# SERVICE BULLETIN

M-1208B

Safety Recall Code 0131

## 2006-2007 XL EXHAUST SHIELD RECALL

Figure 1. Inner Exhaust Shield Installation on Rear Exhaust Pipe

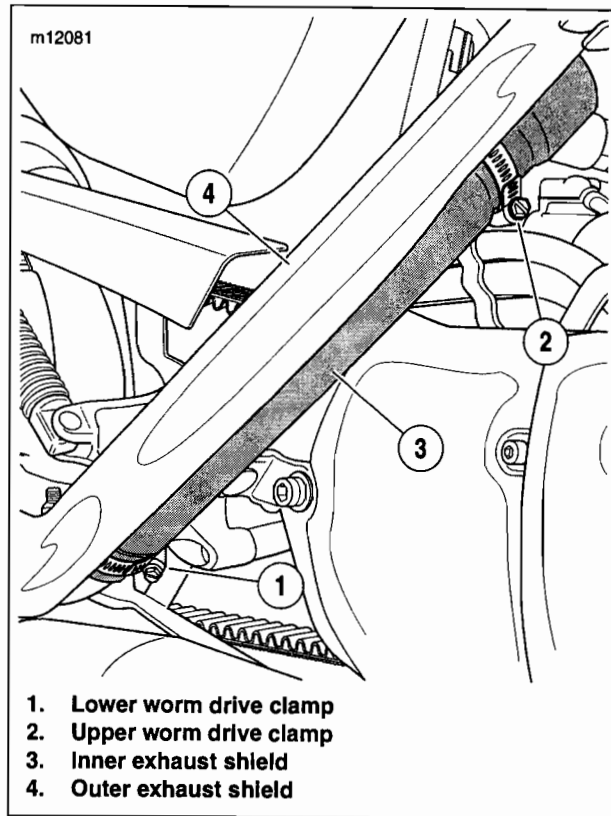
Harley-Davidson has determined that a condition affecting motor vehicle safety exists on selected 2006 and 2007 XL model vehicles. These vehicles have a condition whereby the pant leg of some riders can have direct contact with the exhaust pipe. This condition could cause the pant leg to char or burn, which could lead to the possibility of injury to the rider.

In the interest of motor vehicle safety and customer satisfaction, Harley-Davidson has elected to initiate a voluntary recall (0131). Recall 0131 consists of installing an additional exhaust shield on the inner side of the rear exhaust pipe, preventing the risk of the rider pant leg having direct contact with the exhaust pipe. You may sell **but not deliver** any affected motorcycles to your customers until the remedy is completed.

See Figure 1. If the vehicle is equipped with an original rear exhaust pipe (header) which does not have the inner exhaust shield installed, proceed to the installation instructions.

1. See Figure 1. Loosen the lower worm drive clamp (1) on the rear exhaust pipe.
2. Loosen the upper worm drive clamp (2).
  - a. See Figure 2. On 2006 model vehicles, loosen the upper worm drive clamp. Rotate the clamp (1) to accommodate the installation of the inner exhaust shield as shown.
  - b. On 2007 model vehicles, completely unfasten the upper worm drive clamp until the clamp opens.
3. See Figure 1. Slide the bottom portion of the **new** inner exhaust shield (3) against the exhaust pipe and into the lower clamp. The clamp should rest on the indented portion of the inner exhaust shield.

4. Tighten lower clamp securely.
5. Place the upper portion of the inner exhaust shield against the exhaust pipe.
6. Install the upper worm drive clamp(s).
  - c. See Figure 2. On 2006 model vehicles, install a **new** worm drive clamp (Part No. 9955) on the indented portion of the inner exhaust shield. Tighten both upper clamps securely.
  - d. See Figure 1. On 2007 model vehicles, install the upper clamp over the indented portion of the inner exhaust shield. Tighten clamp securely.
